**From:** Morgan, Steve  
**Sent:** Monday, January 06, 2014 7:47 AM  
**To:** 'BOSEK, JOHN E'  
**Cc:** Tripp, Anthony; Russell, Merlin  
**Subject:** RE: Questions regarding control joint with water stop on drawing 64BW-5600-500

**From:** John Bechtol [<mailto:johnb.mm@verizon.net>]  
**Sent:** Thursday, December 26, 2013 3:34 PM  
**To:** BOSEK, JOHN E; BODIFORD, MICHAEL S  
**Cc:** 'Gary Givans'; 'chris'  
**Subject:** Questions regarding control joint with water stop on drawing 64BW-5600-500

TITLE	64BW5600500
CLEAN HARBORS FLORIDA, LLC 170 BARTOW MUNICIPAL AIRPORT BARTOW, FLORIDA 33830 CONCRETE SLAB MIX TUB AREA - LAYOUT & DETAILS	
DRAWING NO.	64BW-5600-500
REV.	0

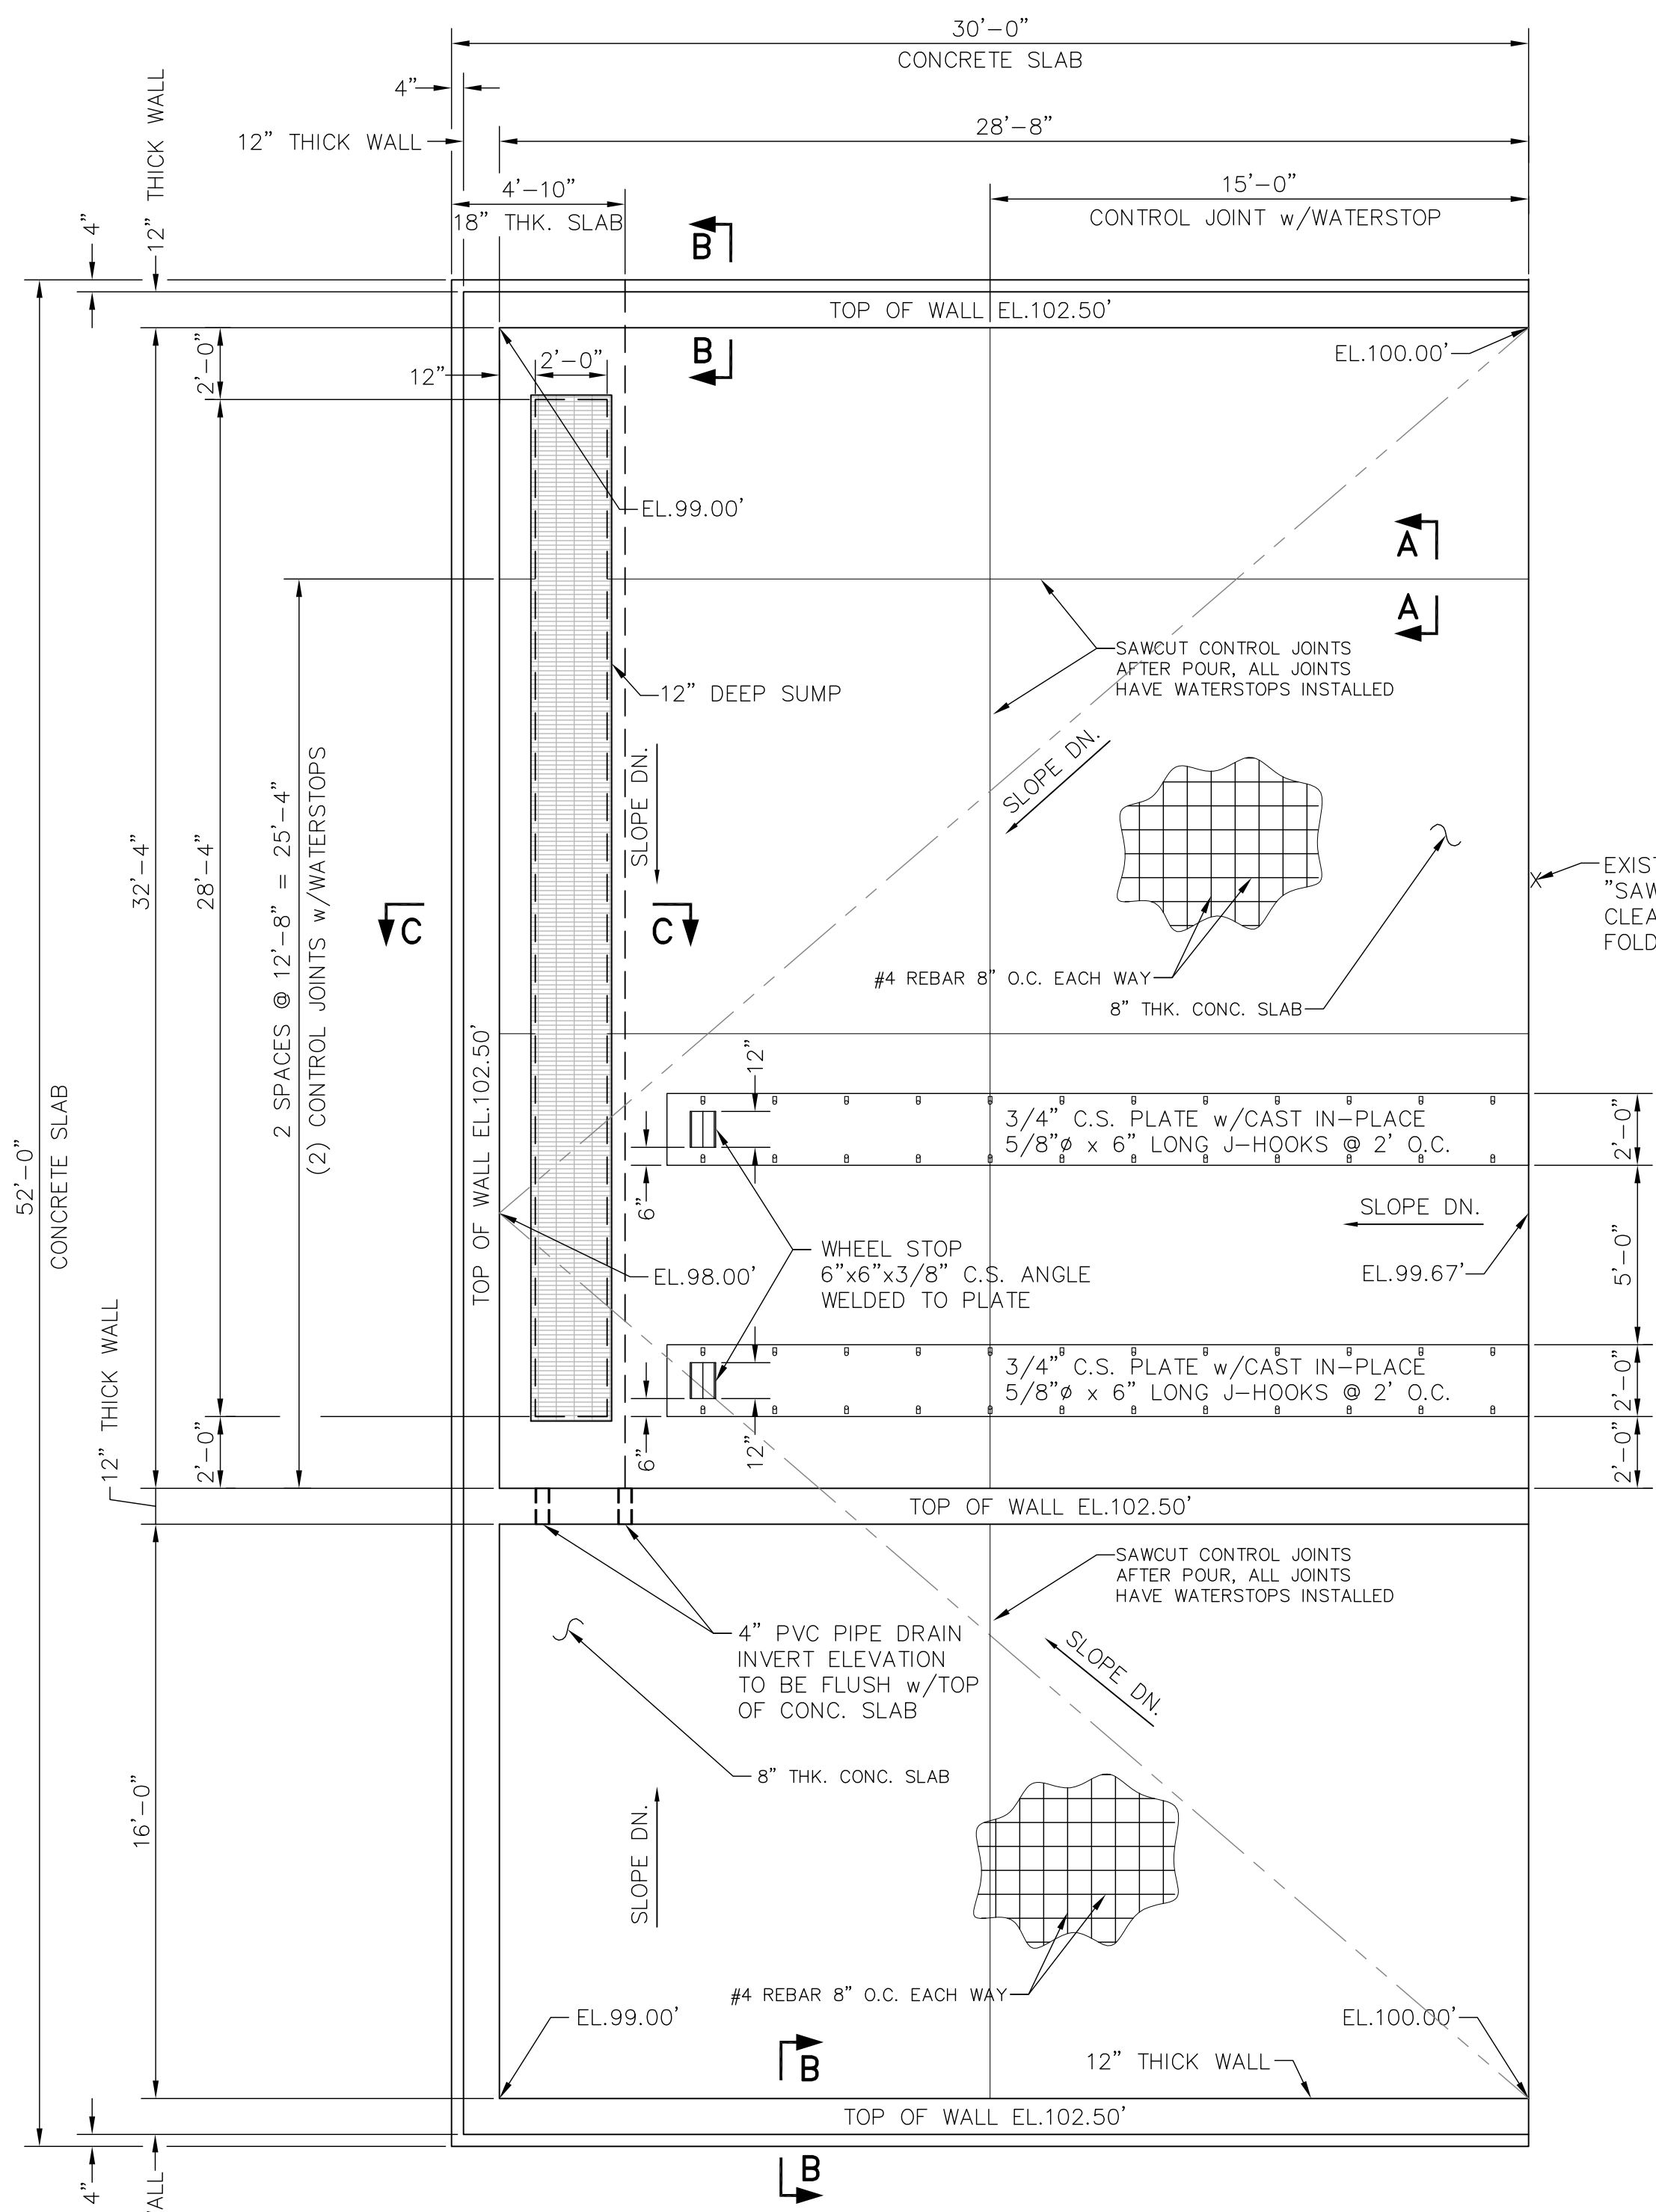
Before we pour the Concrete Slab Mix Tub Area, we have the following comments about Section A-A on drawing 64BW-5600-500.

1. The American Concrete Institute recommends that the saw cut be at least  $\frac{1}{4}$  of the thickness of the slab. For our 8" slab that would be 2" deep.
2. In our opinion the 6" neoprene water stop laid horizontally beneath the rebar matt will interfere with the crack propagation at the control joint.

- a. We believe the result will be either the crack will propagate from the bottom of the saw cut to one of the ends of the water stop,
  - b. or the crack will not propagate at the saw cut and the cracking will not be controlled.
3. In either case we think that the water stop laid horizontally will not stop water and will interfere with the intended crack propagation.

We will construct the joint as you like, however, we cannot guarantee the performance of the control joint as detailed in Section A-A.

We have included a marked up copy of Section A-A and a typical expansion crack control joint for your information. Thank you for your prompt consideration of this request.

The Department has no objection to the proposed change. No permit modification is needed. When you submit your construction certification for the solidification pad, you can identify the change as an approved construction deviation.

Here is the revised drawing "ISSUED FOR CONSTRUCTION" Rev. 0 showing the revised saw cut depth to 2" and the 6" neoprene waterstop is located above the rebar instead of below as shown on Rev. D dated 7/22/13.
